PRODUCT REFERENCE BOOK

for the Tektronix Type

422

oscilloscopes

PART OF AC POWER SUPPLY

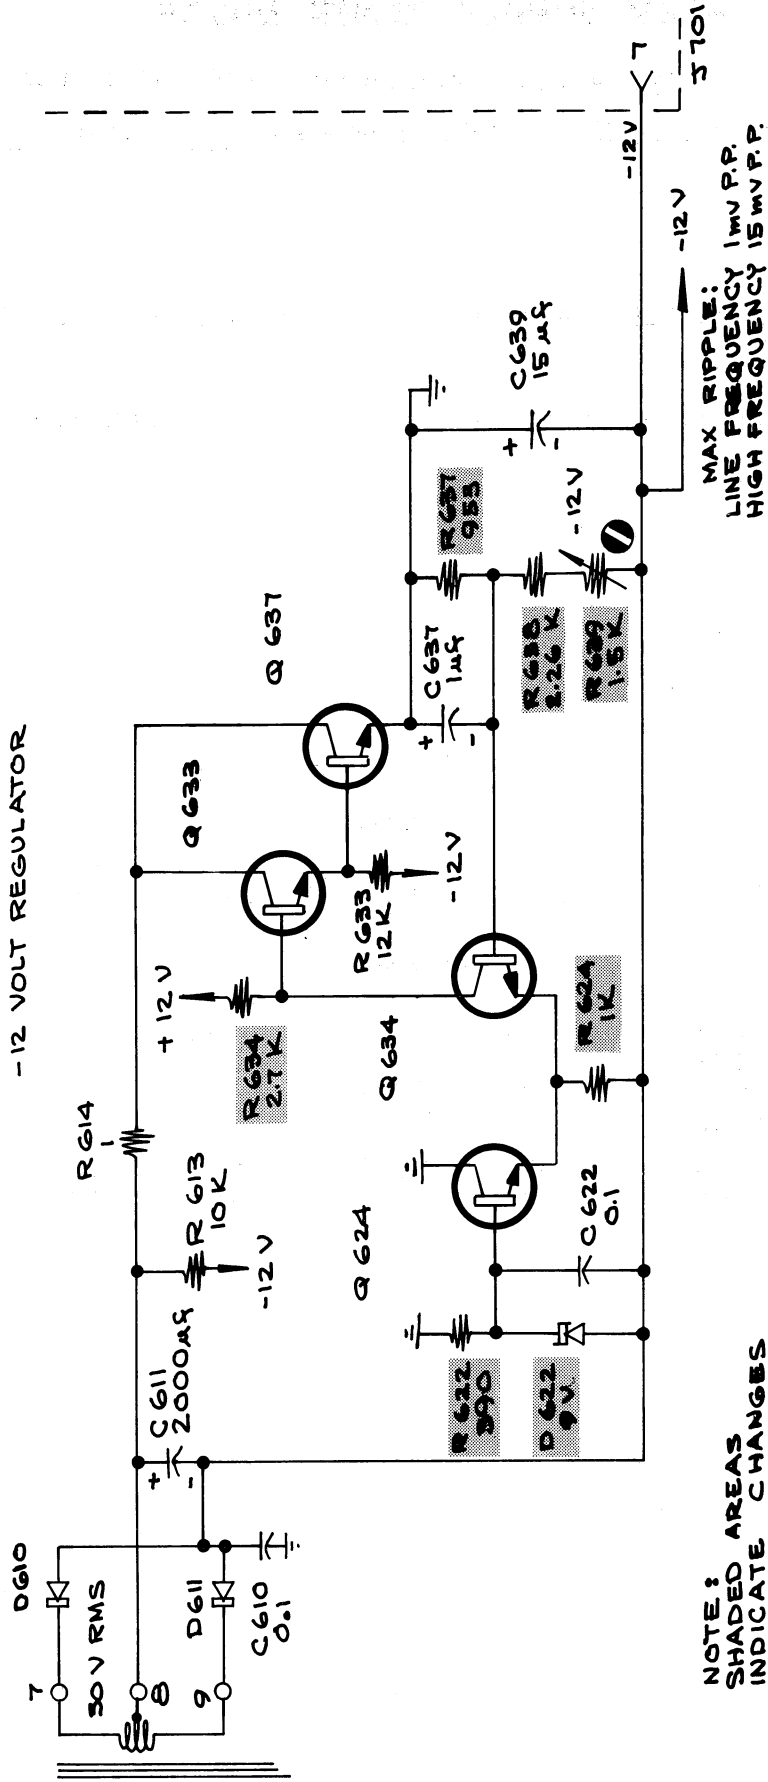
- 3. Refer to Fig. 1 and replace the following parts with the new parts from the kit:
 - () R639: Remove a 2.5 k potentiometer (-12 v), and install a 1.5 k WW potentiometer. (Reinstall C642, removed in step 2.)

NOTE: SHADED AREAS INDICATE CHANGES

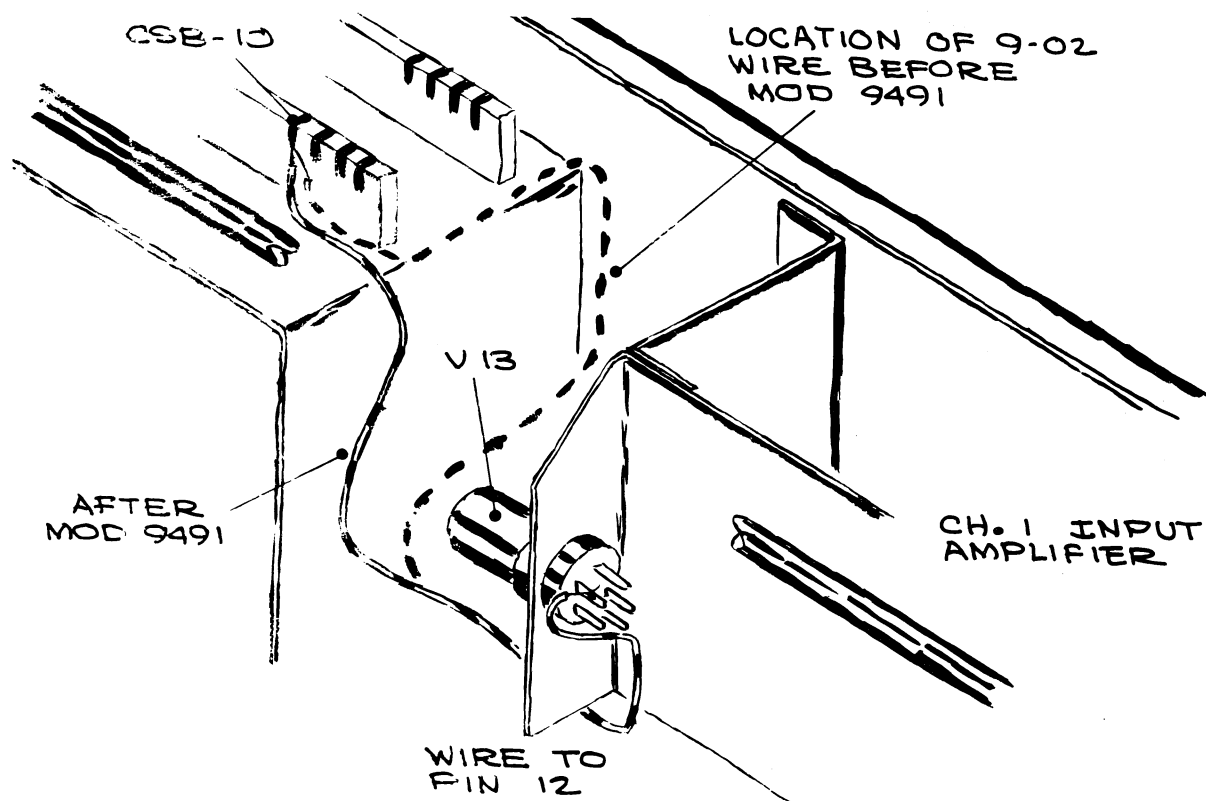
Sweep start transients are being fed into the vertical amplifier by way of the filament wire of V13 and the wire from connector M, Cal Board to connector D, Ch 2 Input Amp Board.

The sweep feed-through is reduced by:

BEFORE
M9333

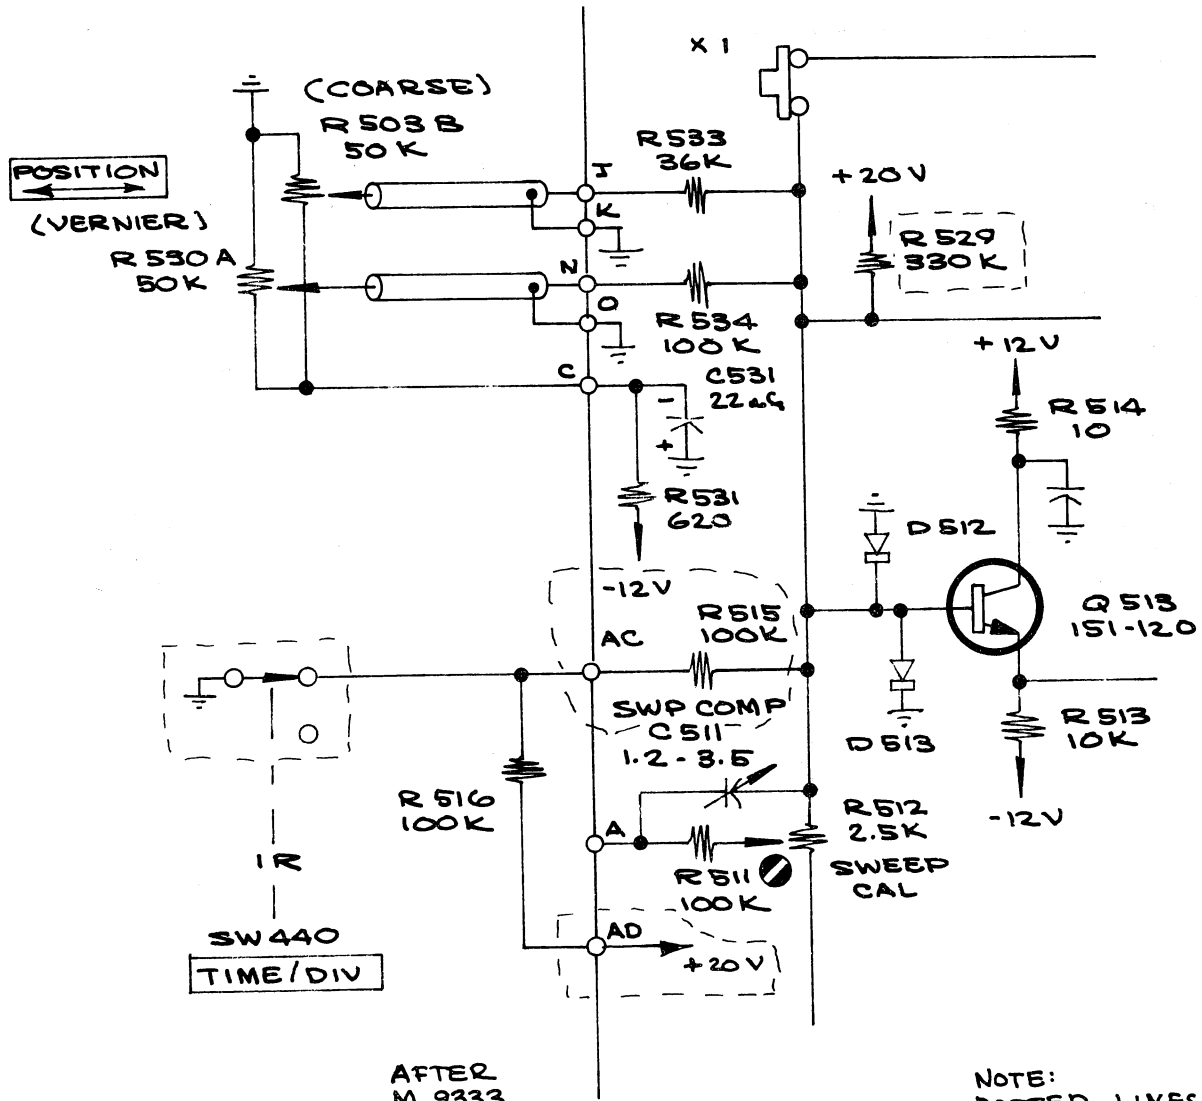
VERTICAL SWITCHING AND OUTPUT AMPLIFIER
CIRCUIT BOARD MOUNTING BRACKET ADDED
TO REDUCE HIGH VOLTAGE RADIATION

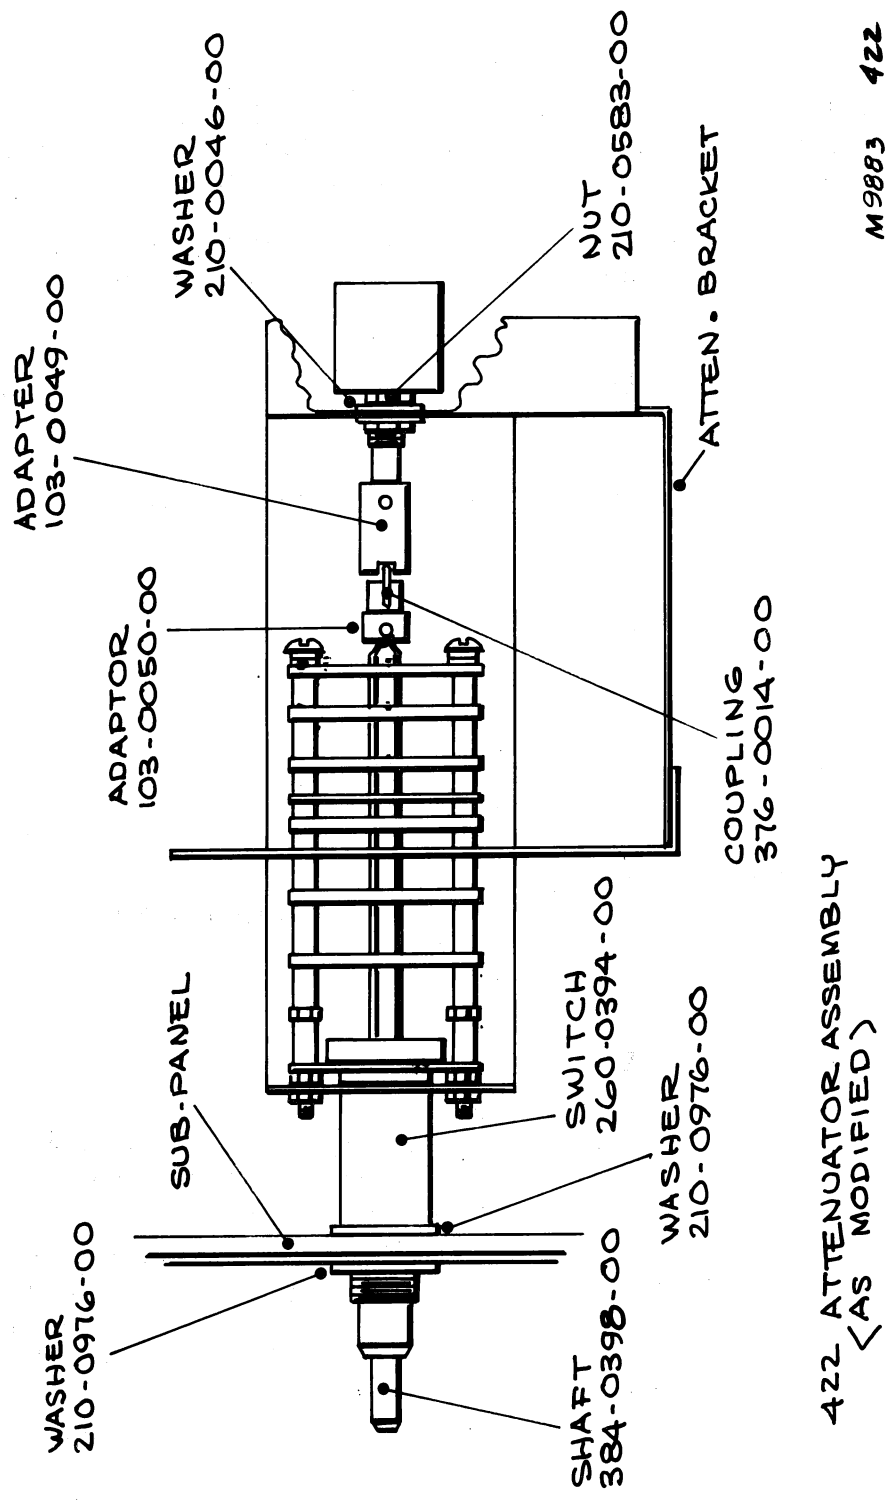
-12 V POWER SUPPLY
CAPACITOR CHANGED TO
ELIMINATE OSCILLATION

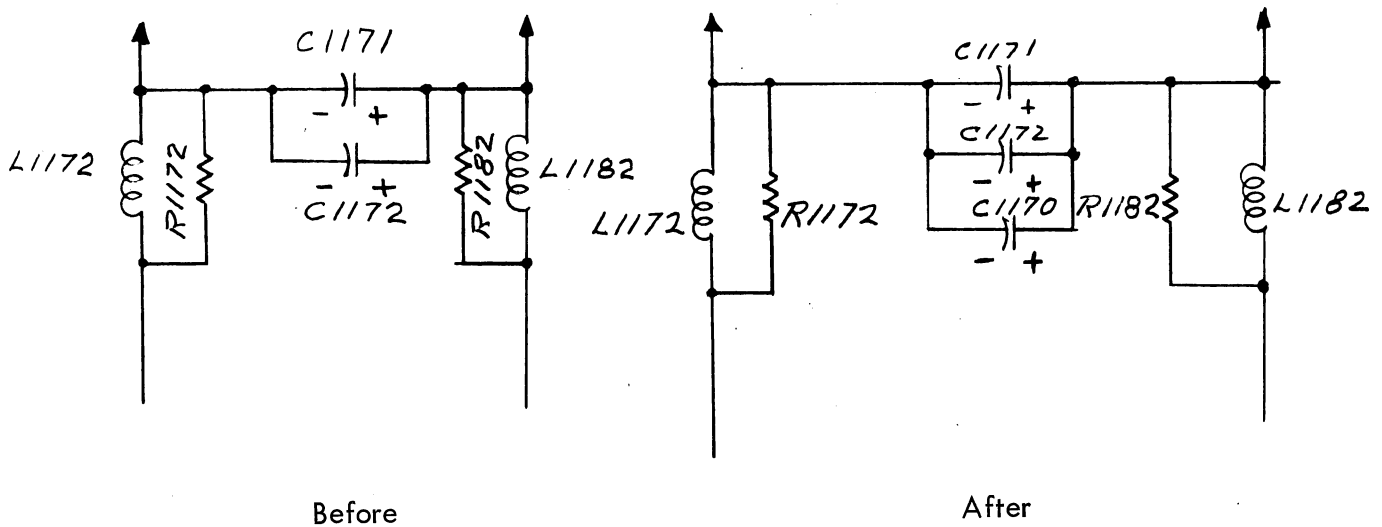
Add C1170, a 0.1 μ F 50 V capacitor, in parallel with C1171 and C1172 located on the lower left hand corner of the DC power connector circuit board. "C1171" and "C1172" are stamped on the board. Also, see the AC-DC power supply instruction manual (page 4-3) for additional locational information.

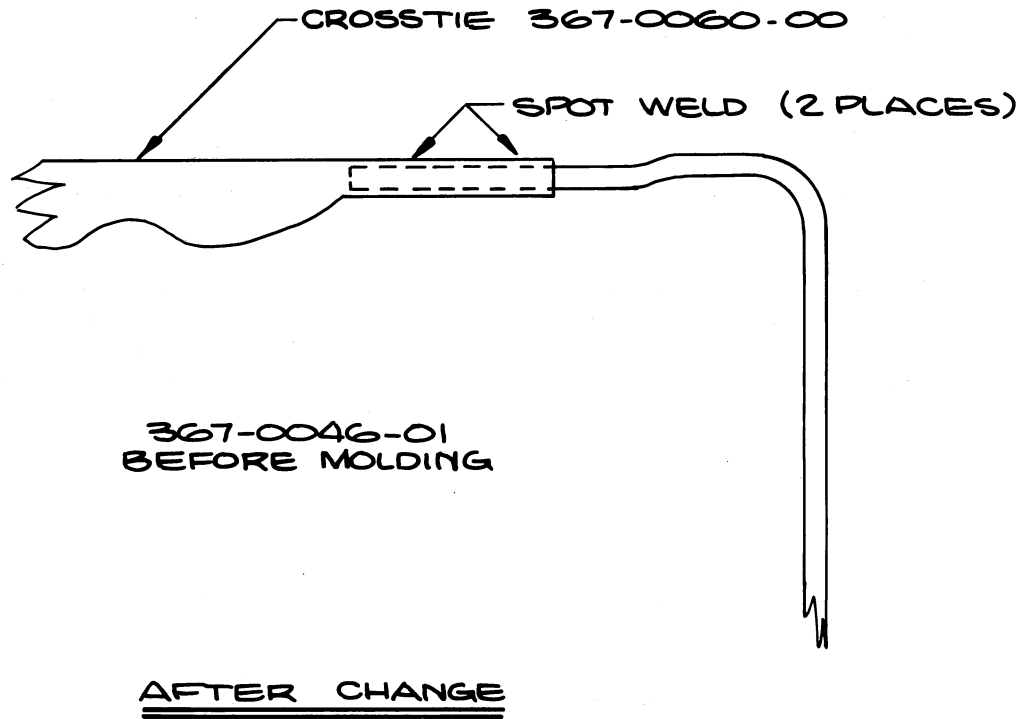
BATTERY VENDOR AND BATTERY PART
NUMBER CHANGED TO OBTAIN INCREASED
AMPERE HOUR CAPACITY

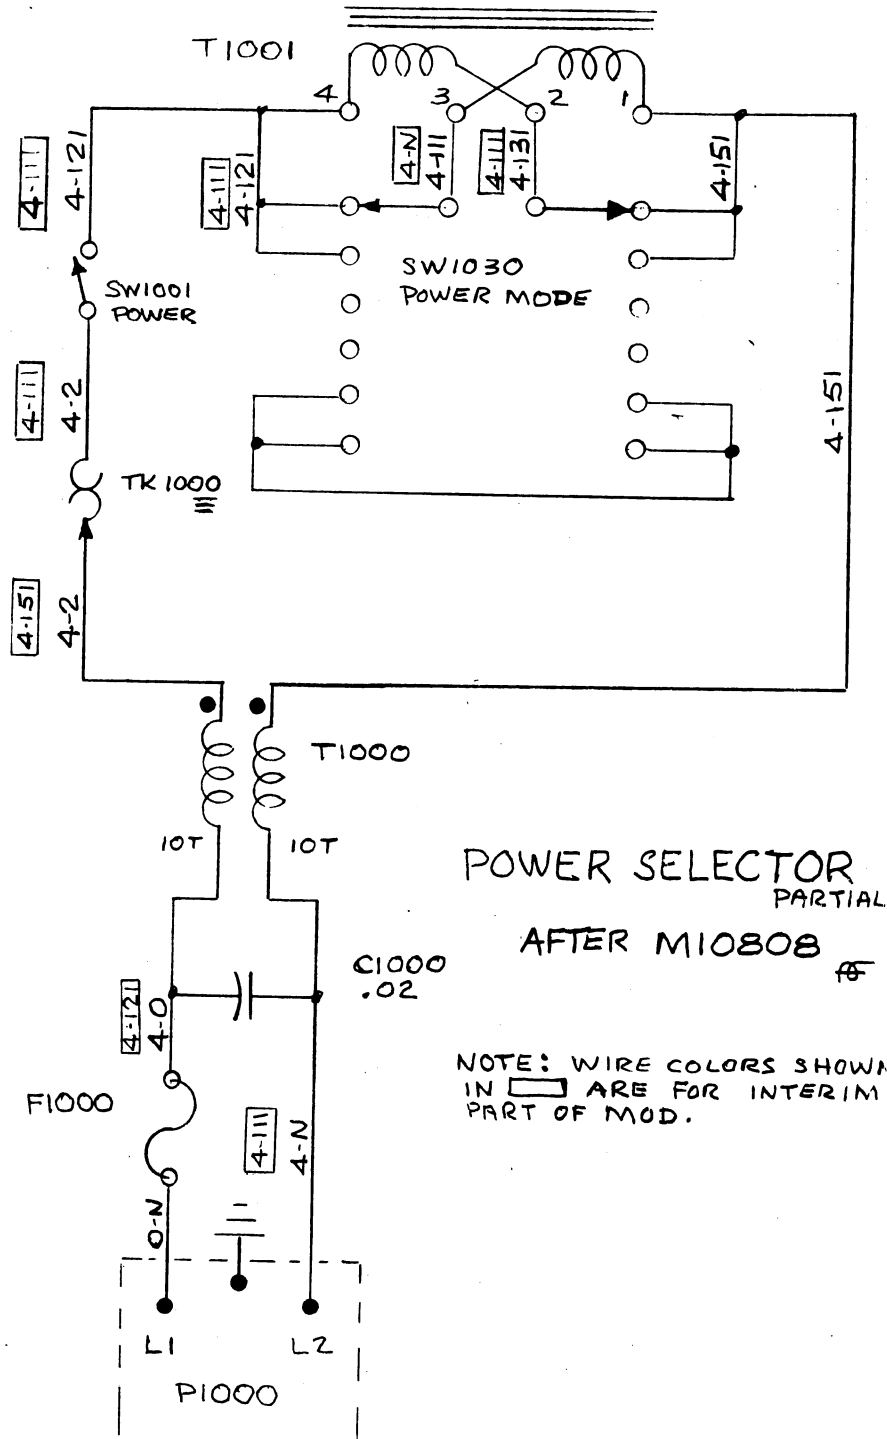
DC POWER CONVERTER CIRCUIT
BOARD CHANGED TO PROVIDE
BETTER PARTS LAYOUT

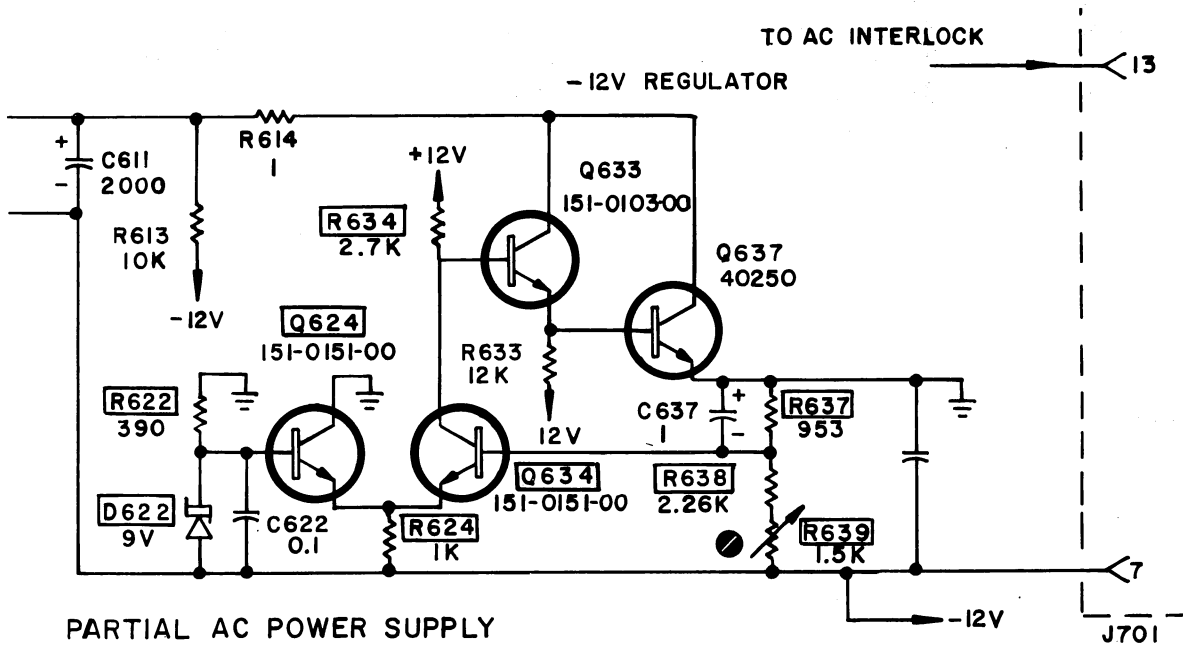
- 1) Change R639 from a 2.5 k composition potentiometer to a 1.5 k wirewound potentiometer.
- 2) Change R622 from 1 k 1/4W 5% to 390Ω 1/4W 5%.
- 3) Change R634 from 2.4 k 1/4W 5% to 2.7 k 1/4W 5%.
- 4) Change R624 from 620Ω 1/4W 5% to 1 k 1/4W 5%.
- 5) Change R638 from 4.02 k 1/8W 1% to 2.26 k 1/8W 1%.
- 6) Change R637 from 6.34 k 1/8W 1% to 953Ω 1/8W 1%.
- 7) Replace D622 with a 1N936 zener diode as needed.

FIG. 1

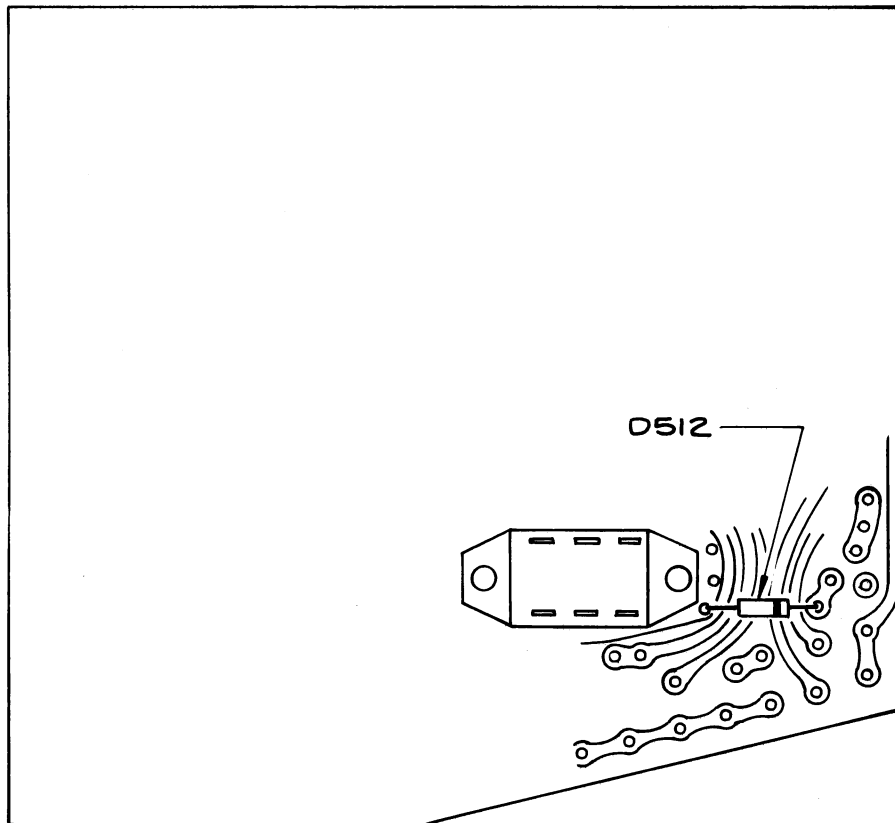
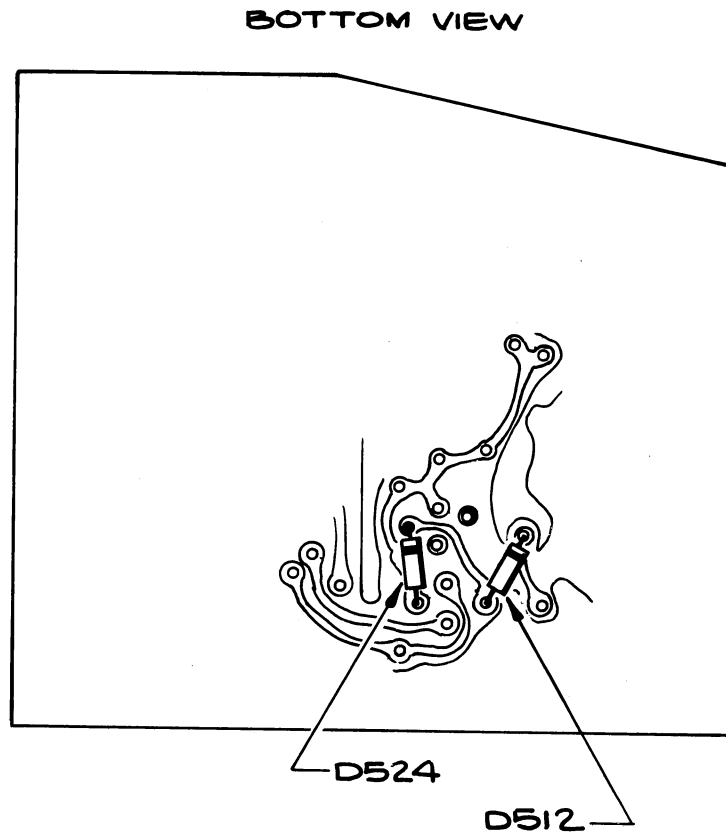
- 1) Remove D512, a 6185 diode, from its location as shown in Fig. 1.
Save for later use.
- 2) Remove the three mounting screws from the Horizontal Amplifier circuit board and lift the board so the bottom side is readily accessible.

- 3) Install D512 (removed in step 1) between the emitter and base of Q513 as shown in Fig. 2.
- 4) Install D524, a 6233 diode, between the base and collector of Q524 as shown in Fig. 2.

TOP OF HORIZ. AMPLIFIER
CIRCUIT BOARD 388-0615-00

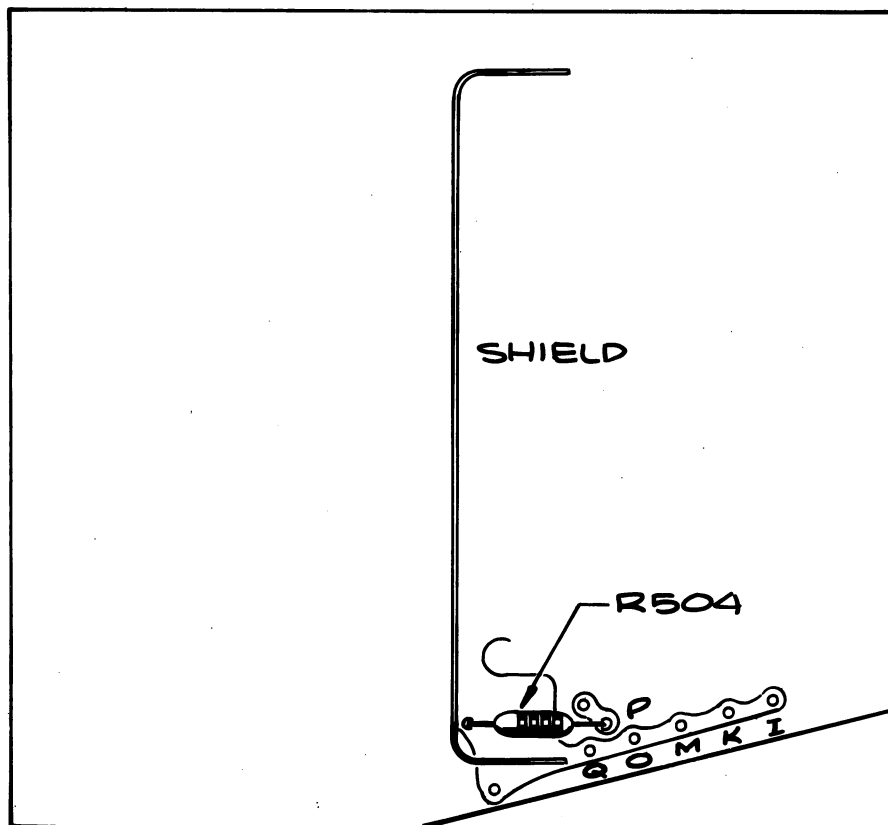
Replace R504, if needed, with a 392Ω resistor. R504 is a 499Ω precision resistor located on the Horizontal Amplifier circuit board as shown in the illustration.
